Office Action Summary	Application No. 10/554,598	Applicant(s) LENORMAND ET AL.	
	Examiner John Fitzgerald	Art Unit 2856

DETAILED ACTION

FIG. 1

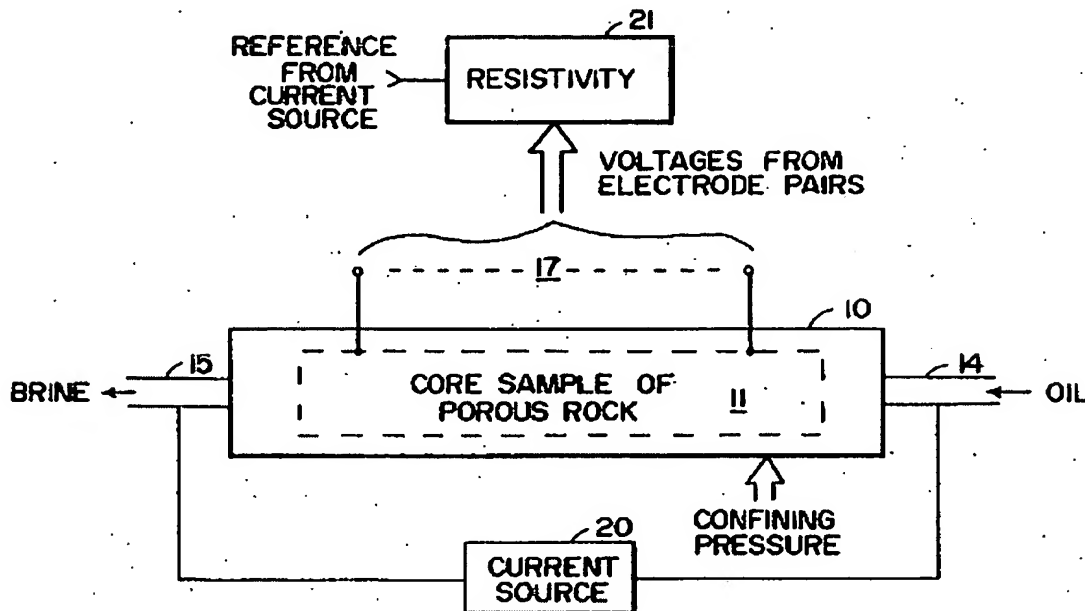
5. Claims 1, 3, 4 are rejected under 35 U.S.C. § 103(a) as being unpatentable over US 4,926,128 to Givens and U.S. 2,583,284 to Wyllie et al. Givens discloses a method of determining the formation factor of an underground zone from drill cuttings taken to the surface including a cell (10) (see Fig. 1 below) to contain the cuttings and having electrodes (17) wherein the cell is filled with a first electrolyte solution (preferably brine) to saturate the cuttings and measuring the conductivity/resistivity (note: conductivity is the reciprocal of resistivity); discharging the first electrolyte solution with a second electrolyte solution (immiscible and oppositely conducting, thus meeting the limitations of claims 3 and 4) and another resistivity/conductivity measurement is made (i.e. cutting saturated with the first electrolyte) and deducing the formation factor (FF) from the resistivity/conductivity measurements. However, Givens does not expressly disclose the cleaning of the cutting before setting them in the cell or the relative concentrations of the first and second electrolyte solutions (claims 3 and 4). Wyllie et al. disclose a method of determining the FF employing many of the method steps recited, as well as that it is customary to wash/clean the drill cuttings before any measuring tests to remove "fines and mud" as well as remove residual "oil and salts." It would have been obvious to one having ordinary skill in the art at the time the invention was made to wash or clean the drill

cuttings thus removing stray factors that might interfere/offset the resistivity/conductivity measurements (i.e. remove contaminants) (Wyllie et al.: col. 6, line 63 to line 70).
